Intel® 80314 I/O Processor Companion Chip

Specification Update

| *July 2004*

Order Number: 273759-006

Figure 1. Power-Sequencing Requirements

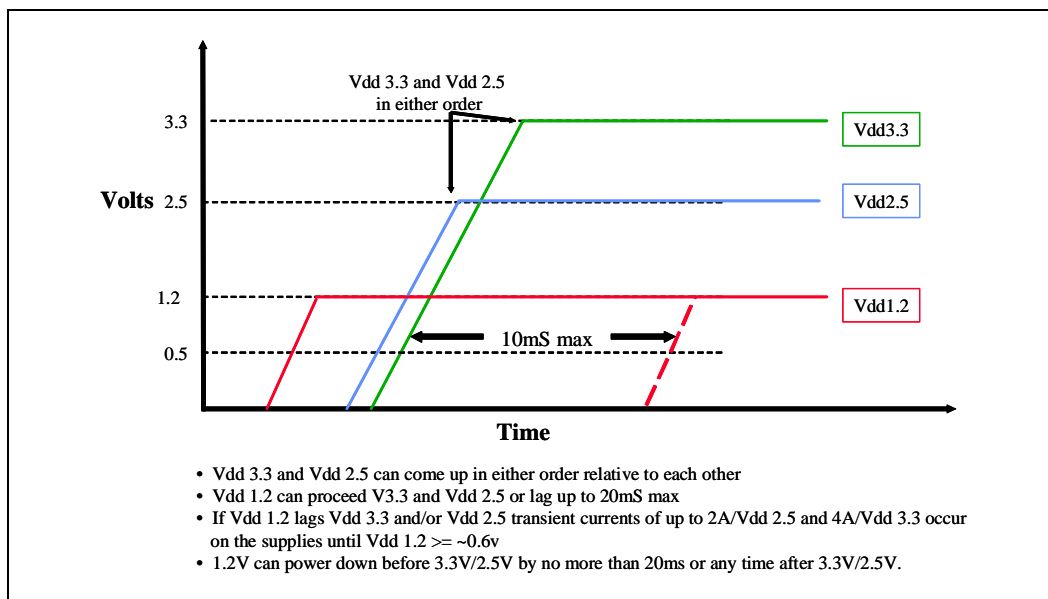
7. Power-sequencing requirement

Issue: The power-up and power-down sequences of the 80314 1.2 V/2.5 V/3.3 V supply rails has been revised from version 003 and 004 of this specification update. The power sequencing requirements initially presented in version 003 were designed to avoid transient current draw that could appear on the 2.5 V/3.3 V supply rails. Further investigation has determined that no current transients occur when the 1.2 V supply is ramped first. In addition, it is acceptable to ramp the 1.2 V supply after the 2.5 V and 3.3 V supplies as long as the lag is less than or equal to 20 mS. When the 1.2 V rail lags the 2.5 V and/or 3.3 V rail, transient currents of up to 2 A/V_{DD2.5} and 4 A/V_{DD3.3} can occur on the supplies until V_{DD1.2} >= ~0.6 V. The 1.2 V supply can power down no more than 20 ms before or any time after the 3.3 V/2.5 V supplies power down. These requirements are illustrated in Figure 1.

Affected Docs: *Intel® 80314 I/O Processor Companion Chip Design Guide* (Section 11.1)
Intel® 80314 I/O Processor Companion Chip Datasheet
